Re: Minor Project Refinement No. 18 for the TL 6975 San Marcos to Escondido Project

TL6975 San Marcos to Escondido 69 kV Project CPUC Minor Project Refinement Form

**TL6975 SAN MARCOS
to ESCONDIDO PROJECT**
MPR-18
Location 4 Additional Work Area
San Diego County, CA

ATTACHMENT B
MPR-18 Figure

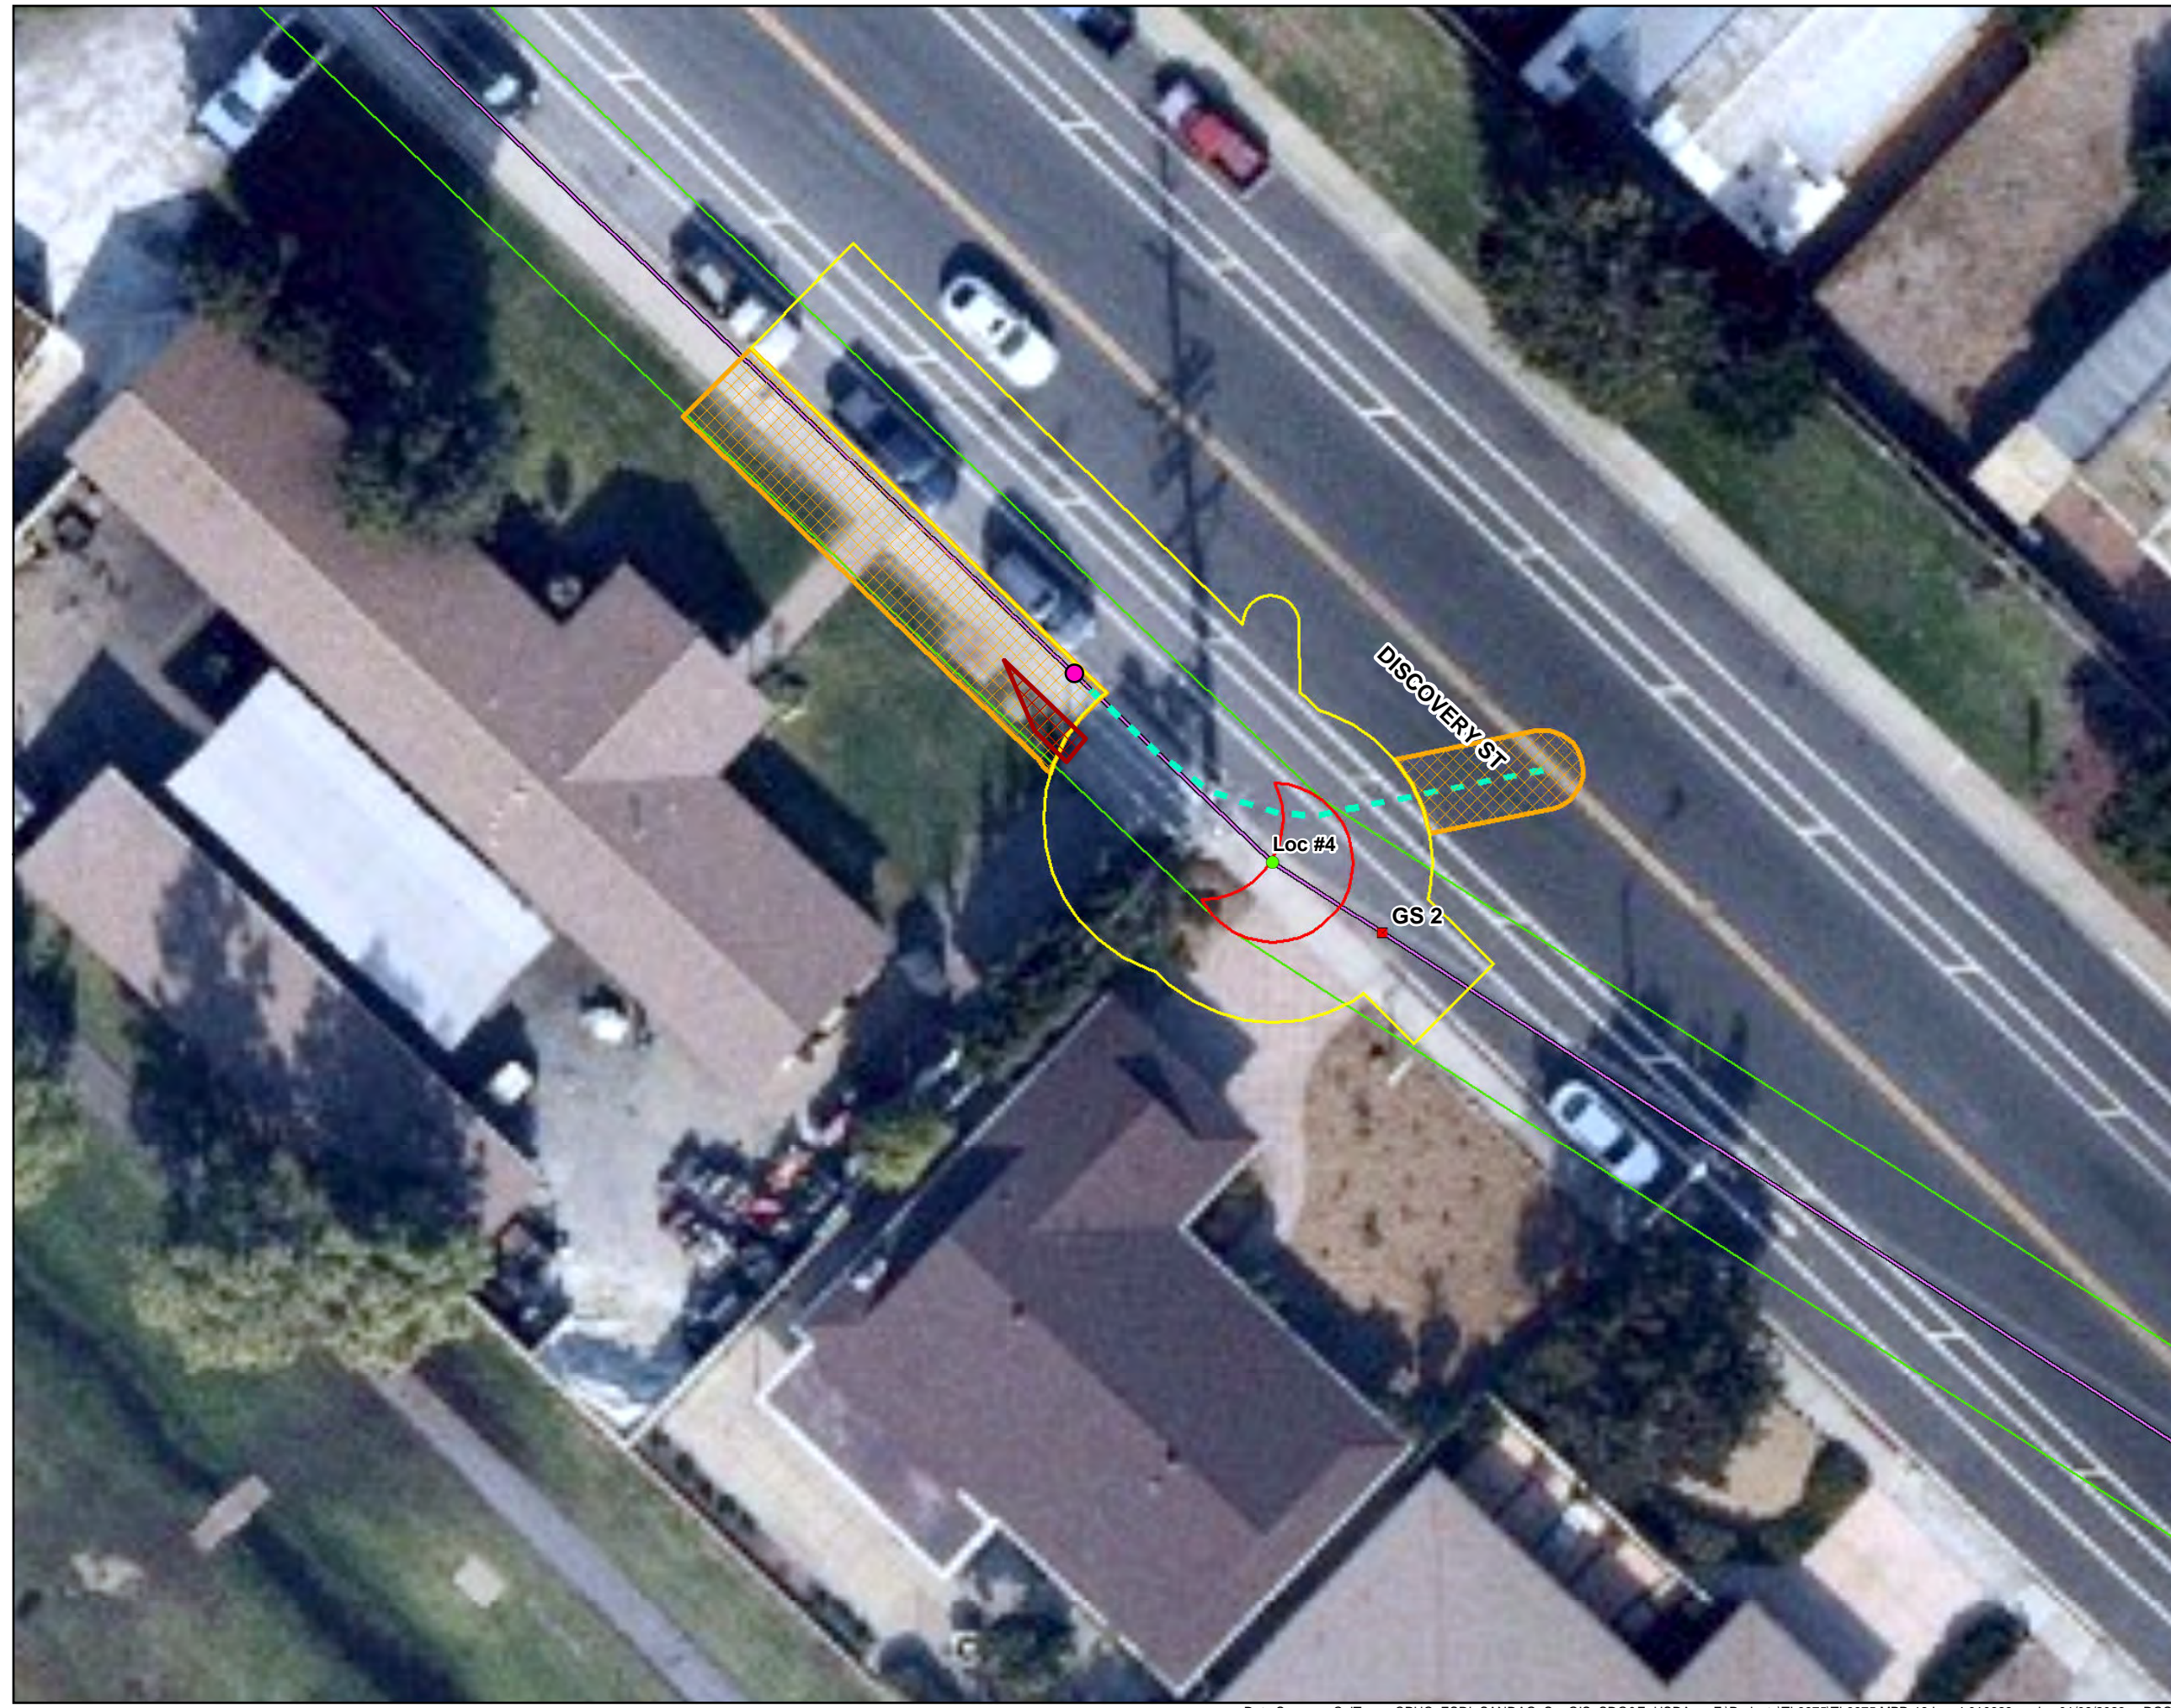
- **Location 4 Proposed Modifications:** The new pole at Location 4 will be installed approximately 25 feet northwest of the original location shown in NTP-1 and IS/MND mapping. An additional 35 square-foot permanent work area will be required at Location 4, where the existing sidewalk will be extended within County of San Diego ROW. An additional

1,090 square-foot temporary work area will be required at this location to complete the pole installation, sidewalk extension, and underground distribution tie-in work. Trenching will be required in order to intercept and reroute the distribution conduit to the new pole at Location 4 (see **Attachment B**). Most of the underground work will take place within the previously approved work area for Location 4. The ornamental grass within the permanent portion of the work area will be removed.

As an alternative, it is being proposed in this MPR-18 request that Location 4 be moved 25 feet northwest. This location would allow enough space for the wet hole direct-bury pole installation and would avoid the need for the multiple day outage that would be required for a same-hole set. As a result of the movement of Location 4, the existing sidewalk must be extended in order to allow pedestrian flow around the new pole sites, and to meet ADA sidewalk clearance requirements. In addition, underground trenching will take place in order to intercept and reroute the underground conduit.

Photograph 1:

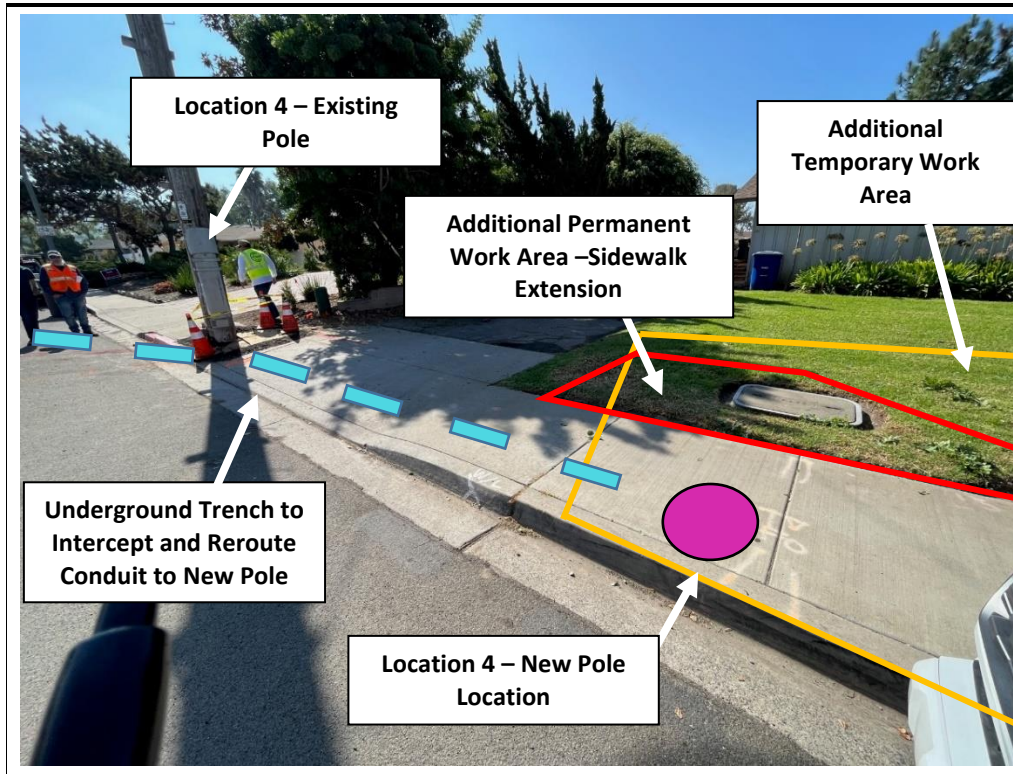
View of the existing and new Location 4 pole sites and the additional work area required for the new pole installation and sidewalk extension. Facing: South

Photograph 2:

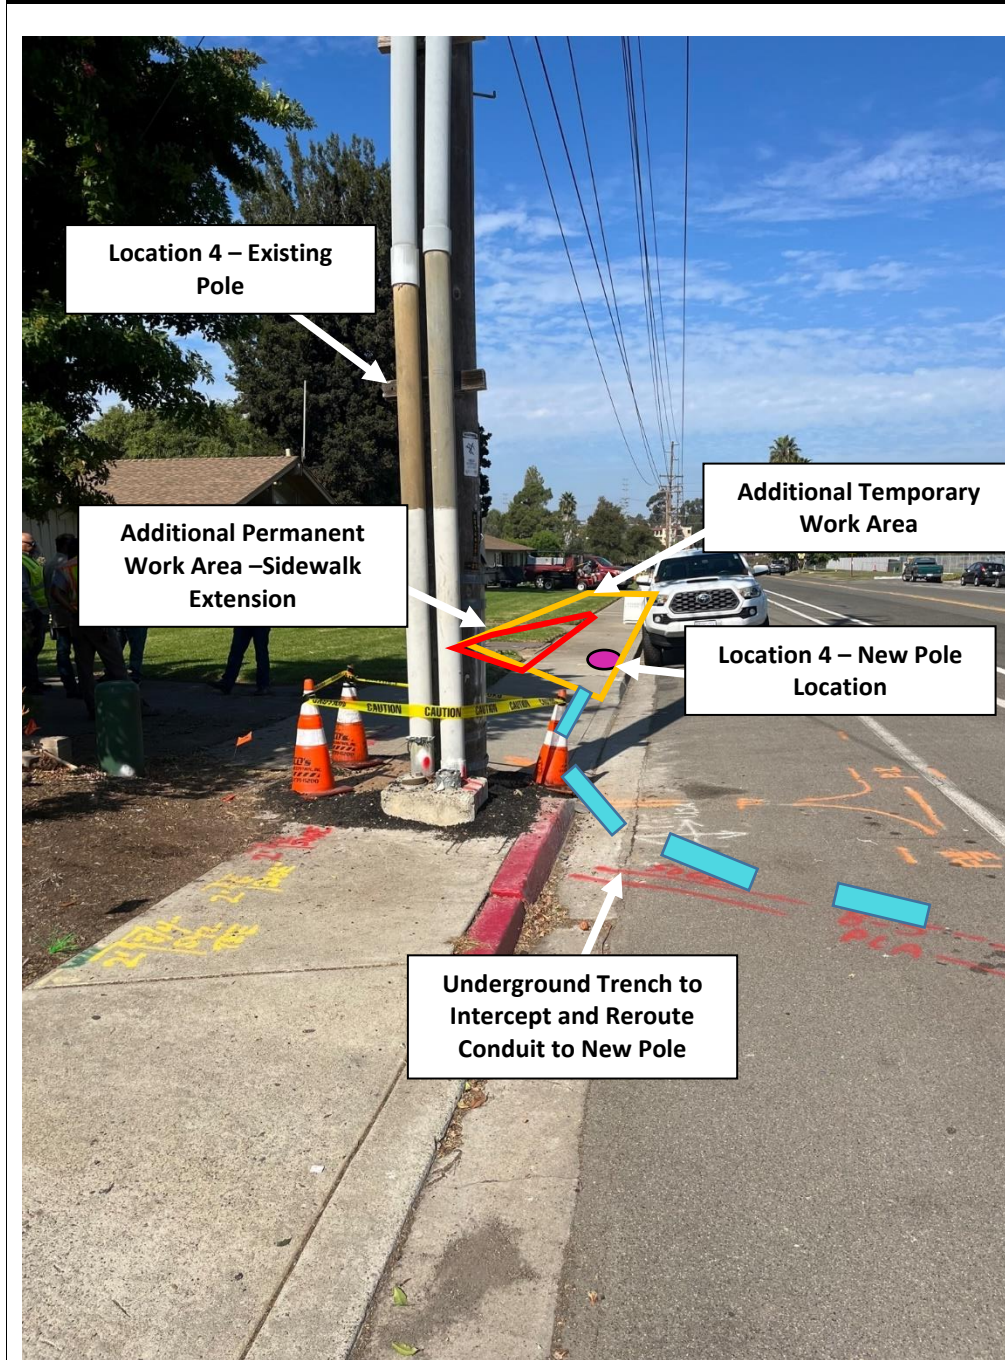
View of the existing and new Location 4 pole sites and the additional work area required for the new pole installation and sidewalk extension.
